MEMO

TO: Scott Cosman, P Eng.
COMPANY: BC MOTI
FROM: Bob Forsyth, P Eng
DATE: 5 April 2024
CC: Zach Crippen, P Eng, Jenna Lee, P Eng.
PROJECT NO.: CA-EI-VG07796.A09
SUBJECT: Proposed Drainage Improvements, Hwy 9 near Miami Creek, Harrison Hot Springs, BC

DRAWN BY: CHECK'D BY: SCALE: AS SHOWN	PROPOSED DRAINAGE IMPROVEMENT HWY 9 NEAR MIAMI CREEK, HARRISON HOT SPRINGS, BC	DATE: APR 2024 PROJECT NO: CHA/EI-VG0779E REV. NO.: 0 FIGURE NO.: 2
SECTION 3

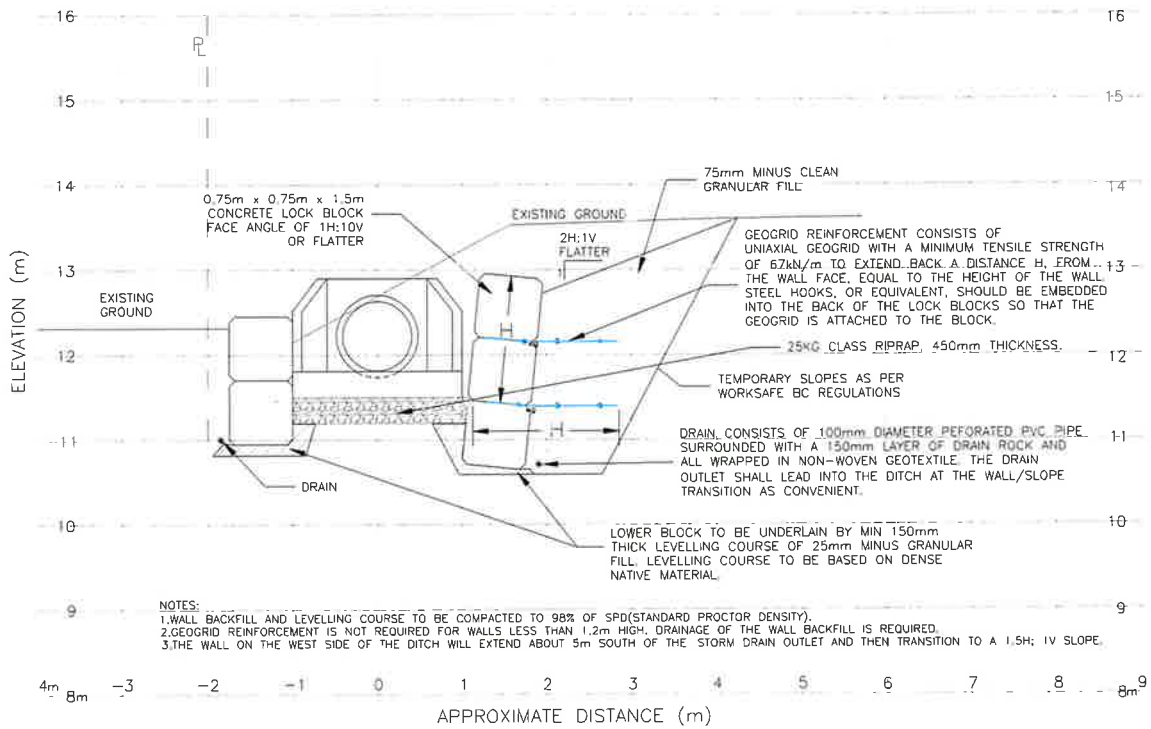
The following recommendations apply to an MSE retaining wall with a concrete lock block facing. A conceptual design of the wall is shown in Figures 2 and 3.

- Concrete lock blocks are 0.75m X 0.75m X 1.5m blocks cast with protrusions at the top that fit into matching depressions in the bottom of the overlying blocks.

- The lower row of blocks should be founded on dense native soil or structural fill placed on top of such. A minimum 150mm thick levelling course of 25 mm minus sand and gravel fill is typically placed below the first row of blocks. The levelling course is graded at an angle so that the wall face is battered at an inclination of 1H: 10V or flatter. The underside of the lower row of blocks should be embedded under the ground surface by at least 0.6m.

- A drain is required at the base of the wall backfill. The drain should consist of 100mm diameter perforated PVC pipe surrounded with about 150mm of drain rock all wrapped in nonwoven geotextile. The drain outlet should lead into the ditch downstream of the retaining wall.

- Wall backfill should consist of free draining 75mm minus sand and gravel (of the material that passes the 2mm sieve, only 5% should pass the .074mm sieve). A portion of the existing embankment may be suitable for re-use as wall backfill, provided that it meets the above criteria.

- Wall backfill and levelling course should be compacted to 98% of Standard Proctor Maximum Dry Density (SPD) within the reinforced zone of the wall. Backfill outside of the reinforcement should be compacted to 95% of SPD (as per Type D embankment fill)

- Where the wall is higher than 1.2m, it should be reinforced with uniaxial geogrid which extends a distance H from the wall face, equal to the wall height. Steel hooks, or equivalent, should be embedded into the back of the lock blocks so that the geogrid is attached to the block. The geogrid is not required for walls less than 1.2m high which is expected to be the case on the west side of the ditch.

- Geogrid should have a tensile strength of at least 67kN/m.
- There will be a temporary construction slope, up to about 2.5m high, on the east side of the ditch. The slope should be inclined as per WorkSafe BC regulations.

- The permanent slope at the crest of the retaining wall should be inclined at 2H: 1V or flatter.
